**Procedure Change Report
Title: 5 Yearly Review of the Methodology
and Process for Determining the Maximum
Reserve Capacity Price**

PC_2011_06

Date: 21 October 2011

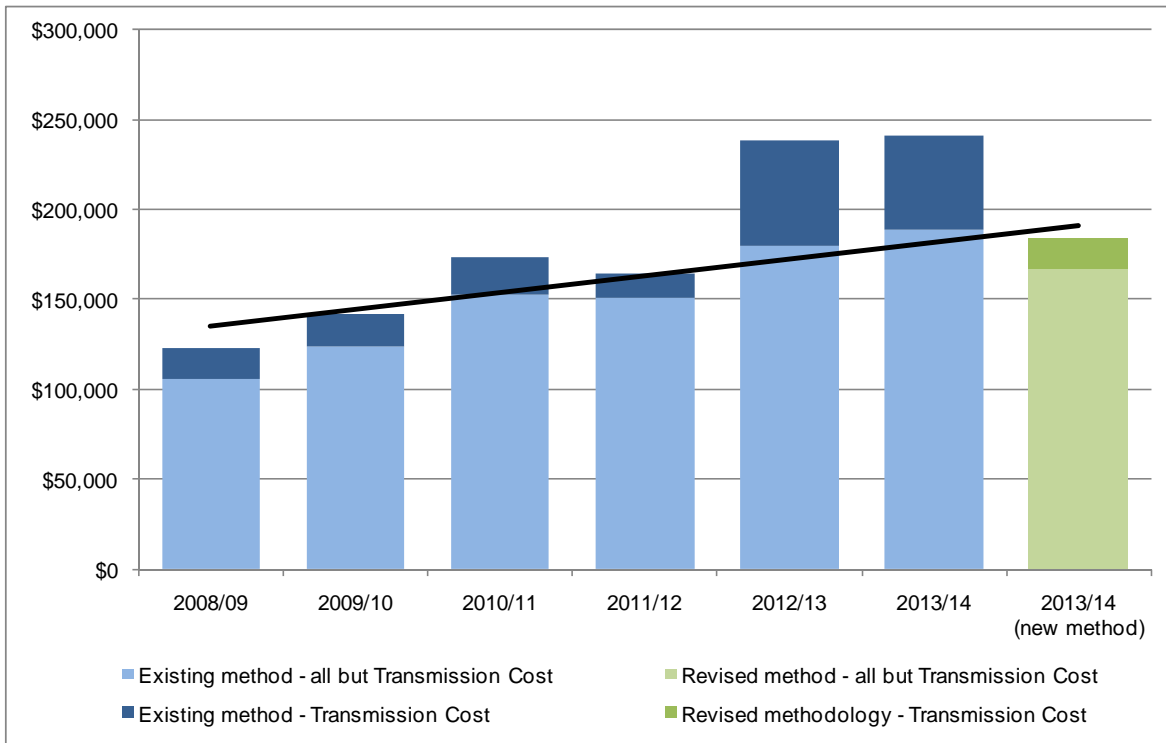
The IMO notes that several of the submitting parties raised concern about the potential for the proposed amendments to contribute to volatility in the MRCP. The IMO observes that much of this concern stems from the indicative impact assessment contained within the Procedure Change Proposal.

The graph below shows the MRCP determined for the Capacity Years from 2008/09 through to 2013/14, along with the estimate of the MRCP that would have been determined for 2013/14 under the proposed methodology. The Transmission Cost component of each MRCP has been highlighted. A linear trend line is also displayed, which excludes the impact of the 2012/13 and 2013/14 MRCP's.

The graph indicates that variability in the Transmission Cost estimate, largely caused by changes in methodology, is the source of much of the volatility in the MRCP in recent years. The graph also suggests that the 2012/13 and 2013/14 MRCP's are outliers and that the proposed changes to the MRCP methodology would see the MRCP return to the trend that existed from 2008/09 to 2011/12.

The IMO considers that the proposed Transmission Cost estimation methodology developed by SKM will provide a more robust approach based on actual data. Further, the use of several years of data in a weighted average calculation should significantly reduce volatility when compared with the current methodology.
